BWEA Response: E&W Grid Code Consultation Ref. D/03. Proposed Grid Code changes to incorporate new generation technologies and DC inter-connectors (Generic Provisions)

Appendix. Detailed comments: Extracts from Glossary & Definitions

Figure 1.

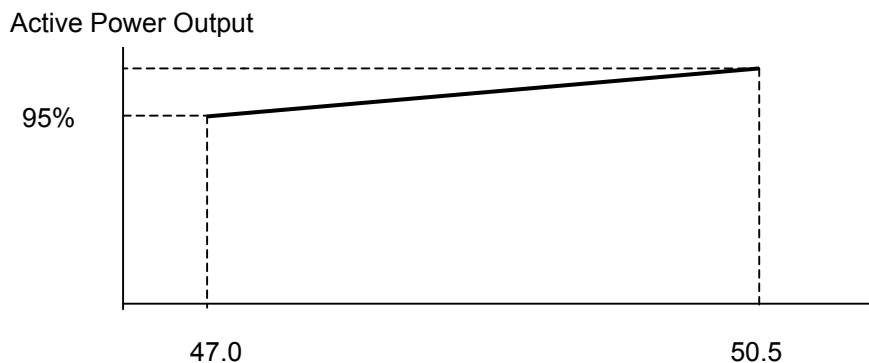
In accordance with standard aerodynamic theory most, if not all wind turbines, are unable to comply with (a). However, it is doubtful that the variation of power with frequency could be measured given the minor changes in frequency and the fluctuations in wind energy. It is not known how other tidal and wave power devices would behave as this is dictated by the theory of their prime movers.

We therefore propose that paragraphs (a) & (c) are deleted and that (b) and Figure 1 are modified as below

(b) maintaining its **Active Power** output at a level not less than the line in Figure 1.

Figure 2

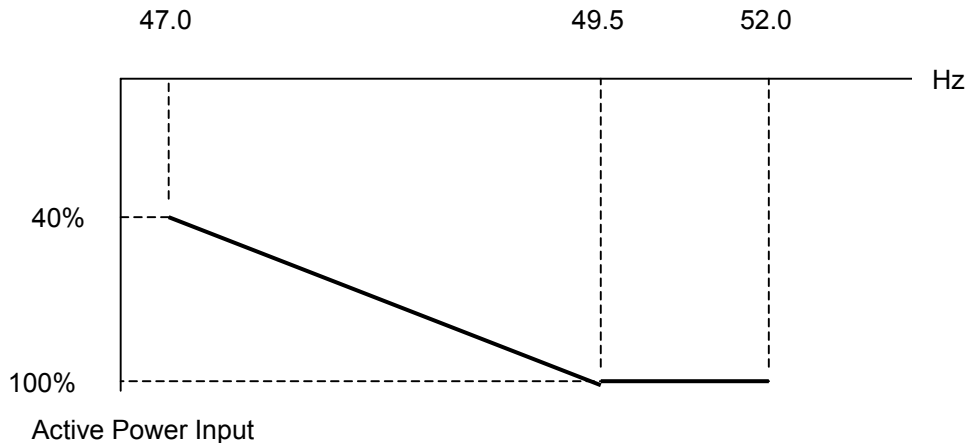
This part of 6.3.3 relates to the Demand action of a DC converter. Any such requirement should therefore be entered in a different section.

This requirement clearly discriminates against Demand Users connected by a DC link compared to those connected by an AC link. It is linked to the setting of low frequency load shedding relays and should be in that section of the Grid Code.

Figure 2 is extremely confusing in relation to Figure 1 and we suggest it is redrawn as below and the text in (d) is modified as per (b) above.
